Re: Agnico Eagle Mines – Meadowbank Division Responses to Waste Rock Storage Facility Dike Design Report Comments

- CIRNAC – September 14, 2018, *Crown-Indigenous Relations and Northern Affairs Canada (CIRNAC) Technical Review Comments of the Design Report Waste Rock Storage Facility Dike – Whale Tail Project under Agnico Eagle Mines Limited's Type "A" Water Licence No. 2AM-WTP1826.*

AMQ15-452 _ WT Pit - Bead Temperature vs. Elevation - 2017

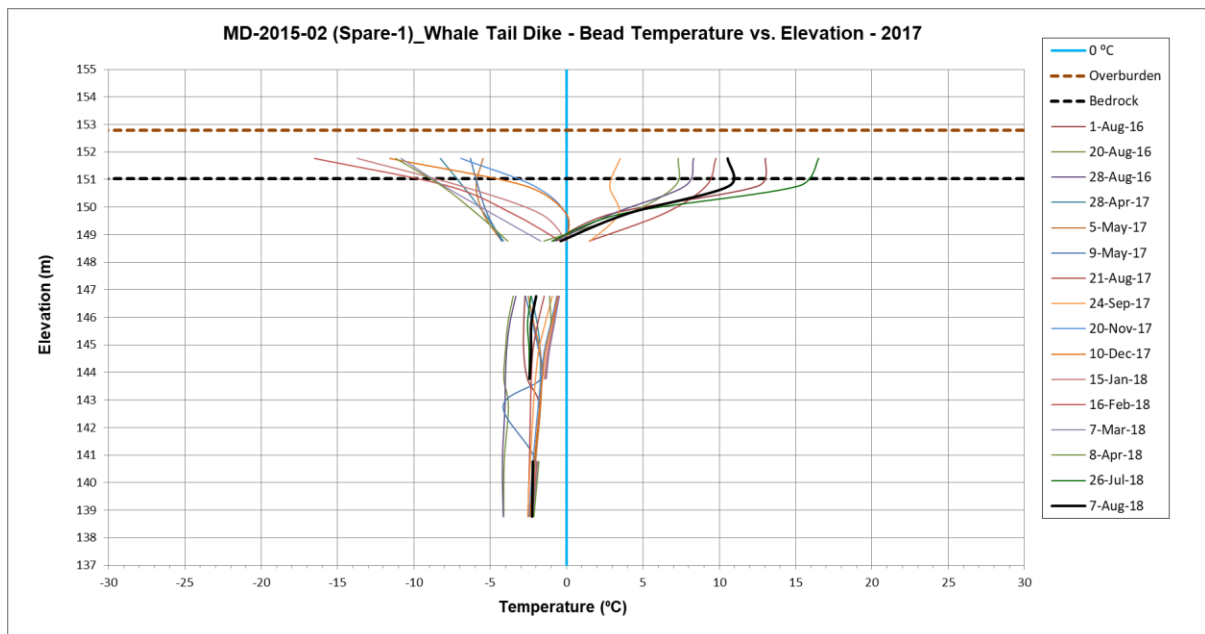
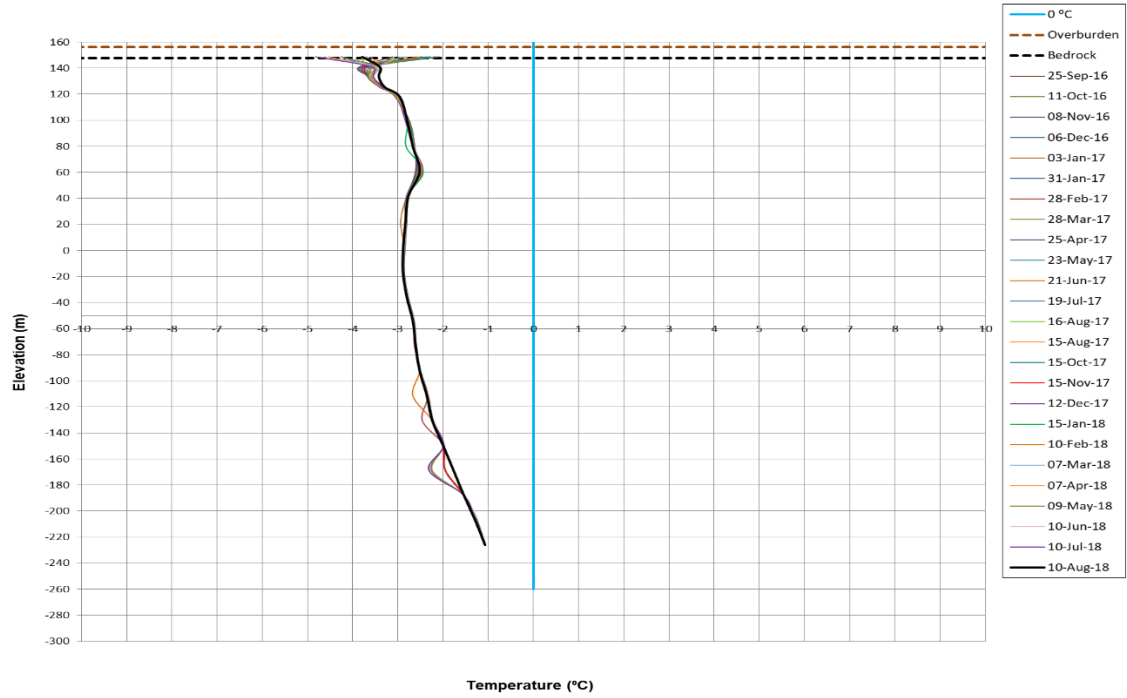
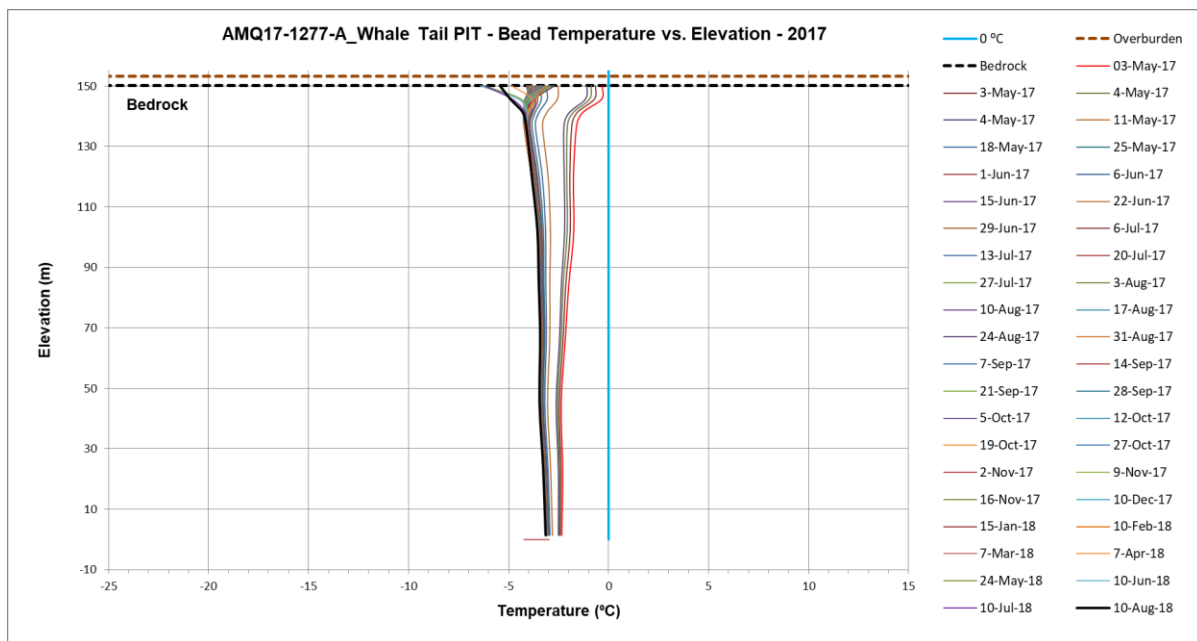
The design report extrapolates one thermal profile at Whale Tail Pit to the WSRF dike. Three other thermal profiles are available at the Whale Tail Pit project, but the thermal profiles were not provided. The design report indicated thermistor strings will be installed, but not the depths nor locations thermal monitoring will be most pertinent.

CIRNAC recommends the thermal profiles from MD-02-2015, AMQ15-452 and AMQ17-1277A (with depths adjusted to a vertical profile) are also provided in the design report, along with a prediction on where thermal monitoring will be most critical in the dike design.

Below are the three (3) requested thermal profiles.

Agnico Eagle understands the importance of thermal monitoring relatively to dike performance and is committed to install, monitor and maintain those instruments until the decommissioning of the dike. Exact locations for thermal monitoring will be selected following excavation of the overburden. Overall, the objective is to install instruments in areas where the dike is the deepest (highest water head on FFAB).
